Illinois Department of Transportation

SUBJECT: MidAmerica St. Louis Airport
Mascoutah, Illinois
St. Clair County
Illinois Project Number: BLV-5101
AIP Project Number: 3-17-0146-TBD
Contract No. SC071
Item No. 02A, April 26, 2024 Letting
Addendum A

NOTICE TO PROSPECTIVE BIDDERS

ADDENDUM A PLAN SHEET REVISIONS

SHEET TITLE
**EXISTING CONDITIONS
& REMOVAL PLAN**

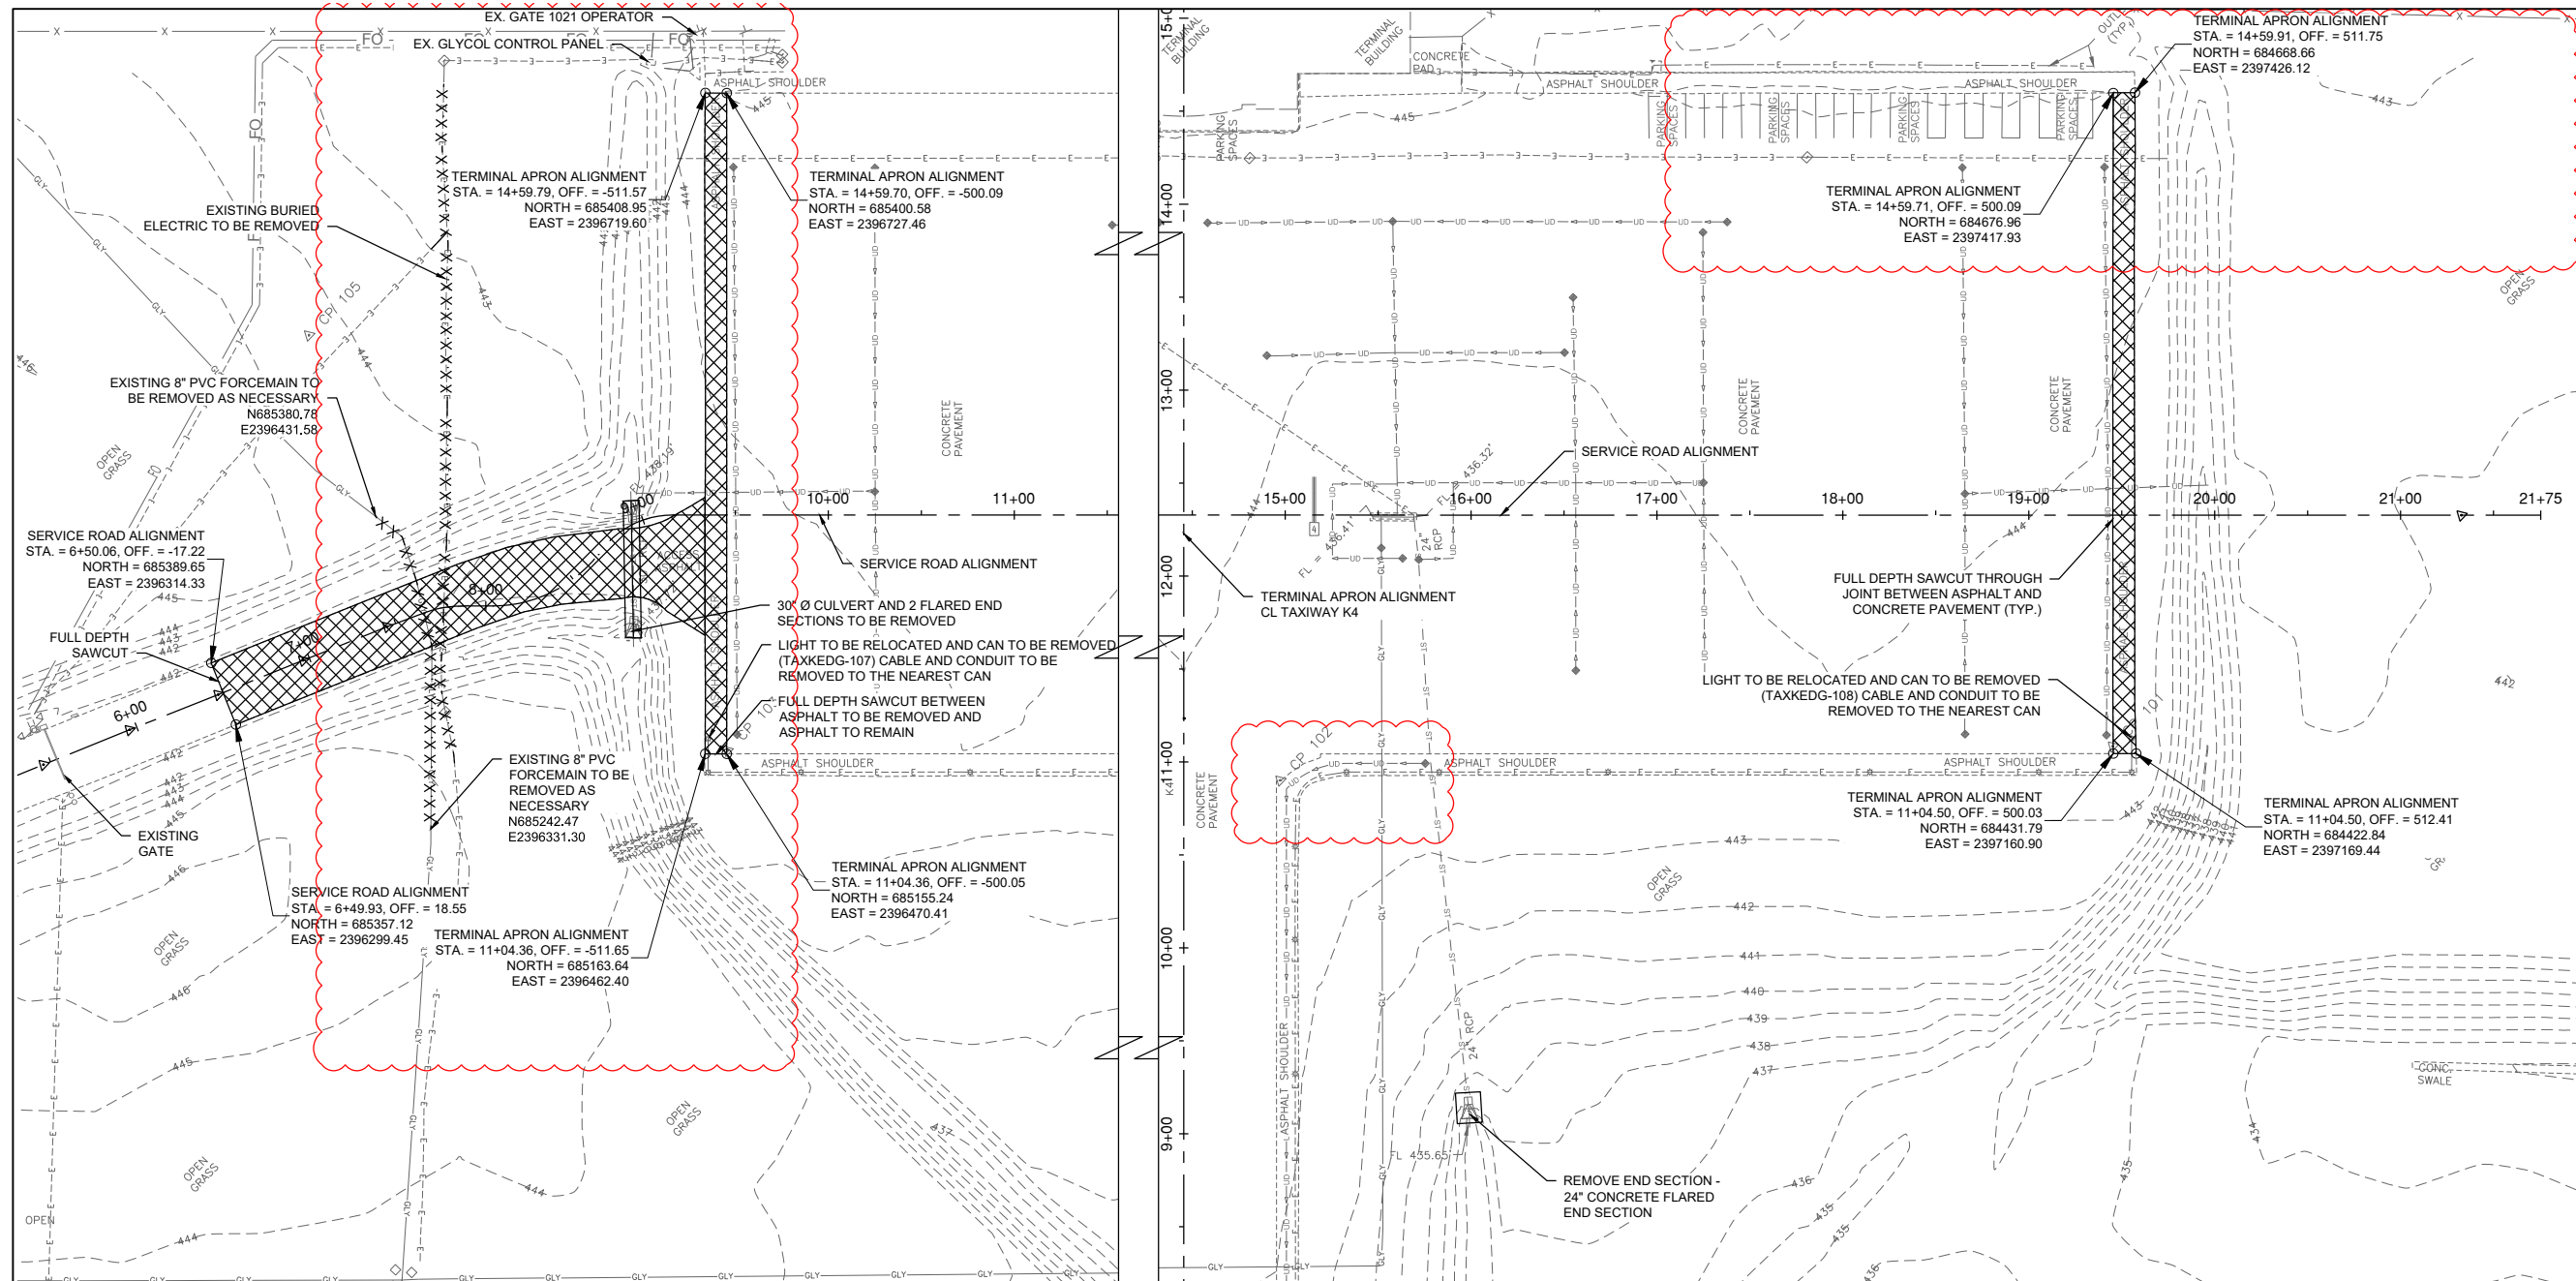
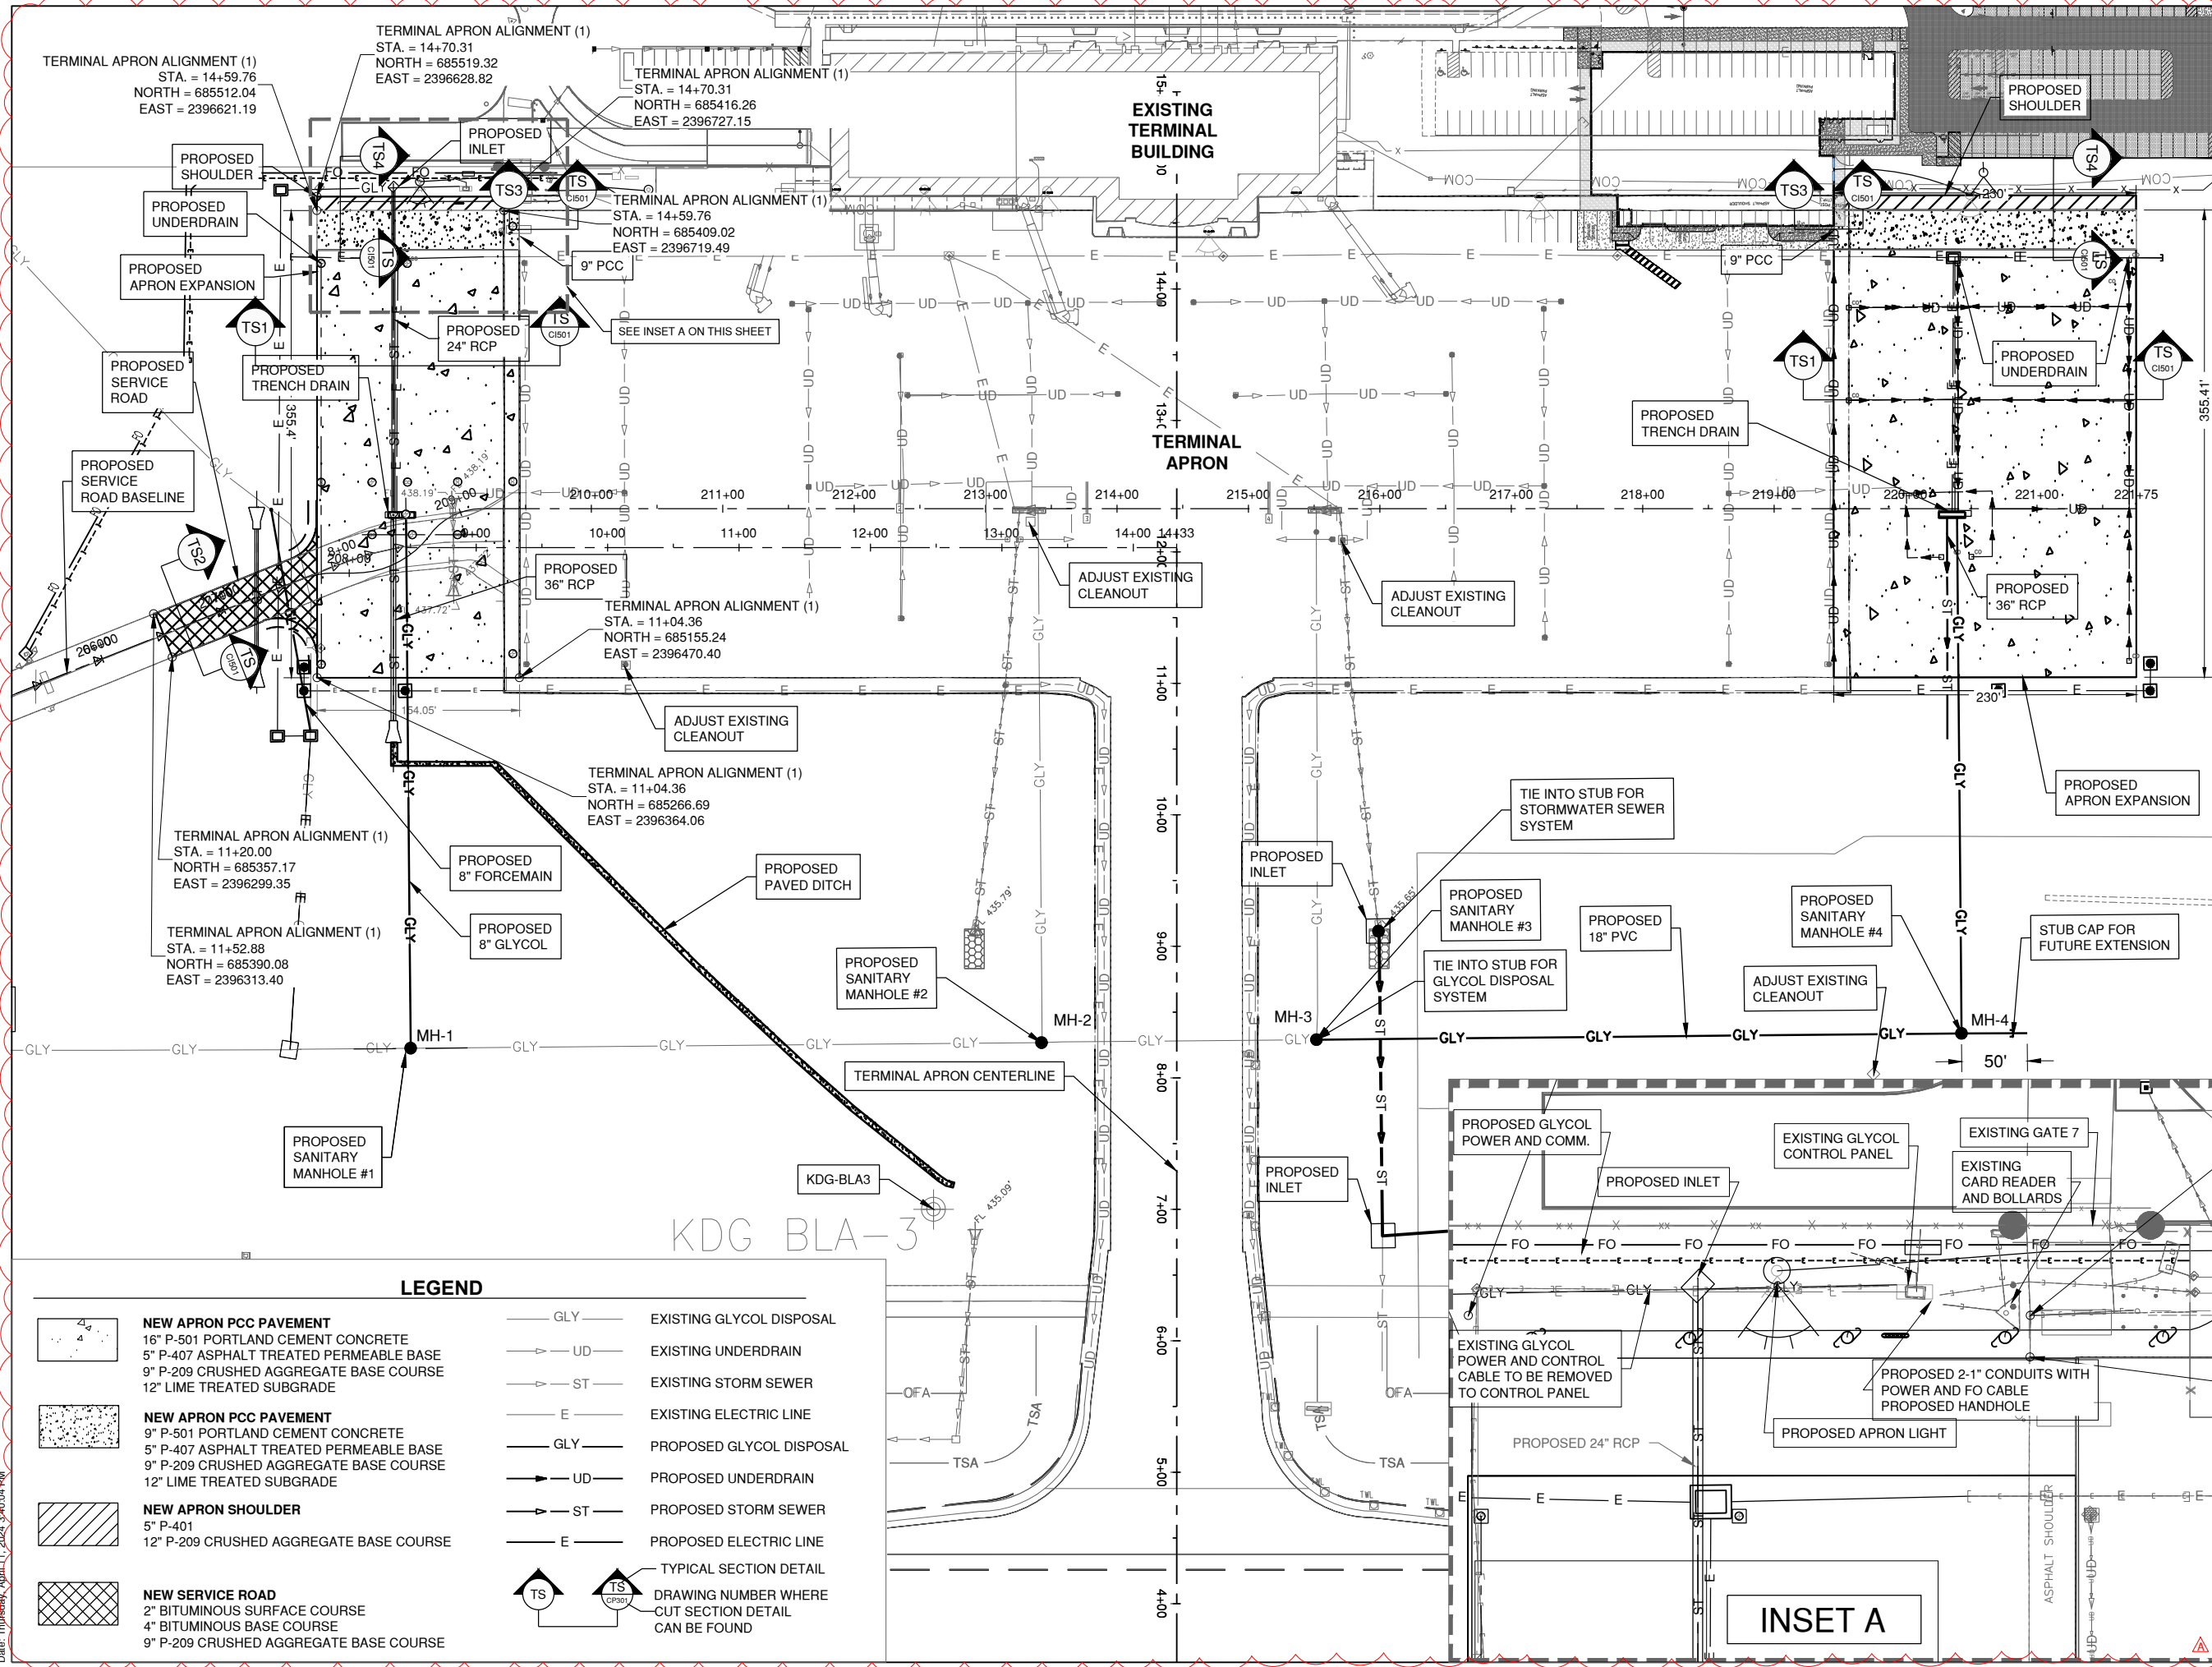
- Updated to cleanup and delete unnecessary linework
- Sheet LG102
 - Updated to cleanup and delete unnecessary linework
- Sheet CD101
 - Updated to add existing features, remove unnecessary linework and clarify symbols on sheet

FUEL TRUCK PARKING SPACE MARKING
 NOT TO SCALE

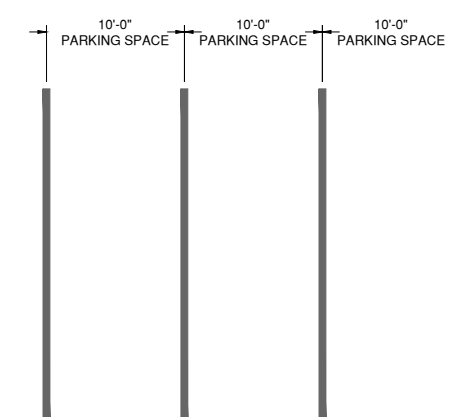
- Sheet CM501
 - Updated to add note for space numbers to Fuel Truck Parking Space Marking detail
- Sheet CM502
 - Updated to add detail for Service Road Yield Sign Support Detail
- Sheet EL101
 - Updated to cleanup linework
- Sheet EL102
 - Updated to cleanup linework and move location of light pole.
- Sheet EL501
 - Updated to add clarify Base Mounted Medium Intensity Light Detail
- Sheet EL502
 - Updated to add dimensions to Concrete Encased Duct Bank details for depth from surface
- Sheet EL507
 - Added for the addition of the Glycol Lift Station Control Panel
- Sheet EL508
 - Added for the addition of the Glycol Lift Station Control Panel

CONCRETE ENCASED DUCT BANKS
N.T.S.

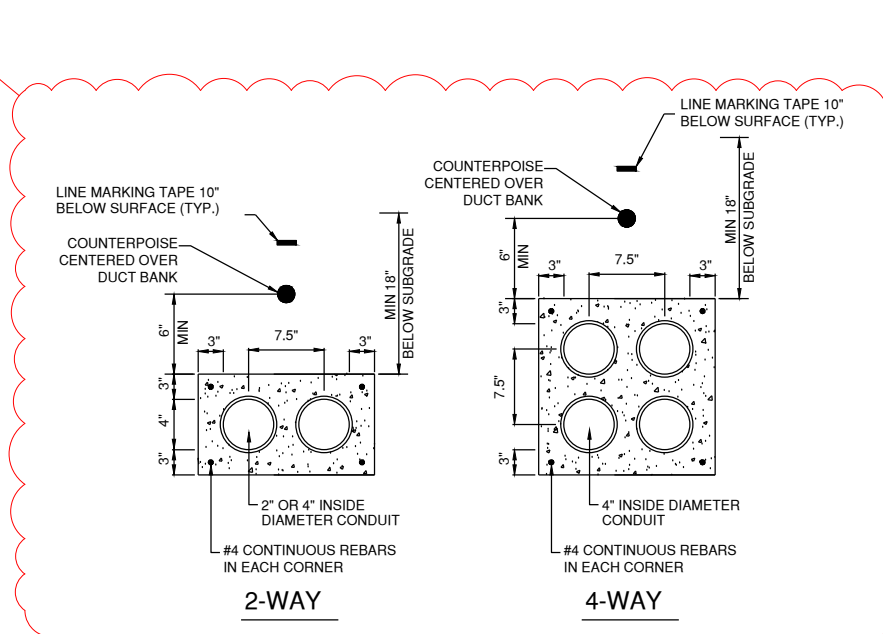
25. Modify base mounted light detail on Plan Sheet EL501
26. Add notes to concrete encased duct detail on Plan Sheet EL502
27. Add Sheets EL507-EL508 for Glycol Lift Station Control Panel
